I.V. Systems Division

Subject: Reply to Your Letter dated December 4 1996

I have reviewed the drawings which were sent to us. These drawings describe changes that have been incorporated into your irradiator control systems. The changes are described as follows:

ATTACHMENT  
NO.1

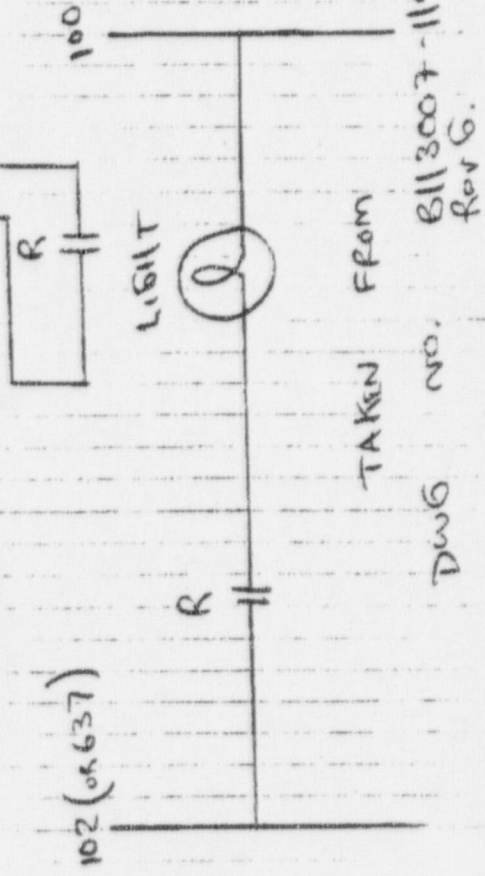
The first change, photo switch on the elevators, is unclear in what part of the circuit this applies. I have revised a copy of the section of the schematic that it appears to apply to, please see first attachment. If this is the case, and I have interpreted your sketch correctly, then it would appear that the solenoids for the elevators would rely on having a light bulb in place to operate. While this is not a safety concern it would be a reliability problem, for example the elevator would not work when the light bulb burnt out. You may choose to use a different set of contacts of relay R to illuminate the light, see second attachment.
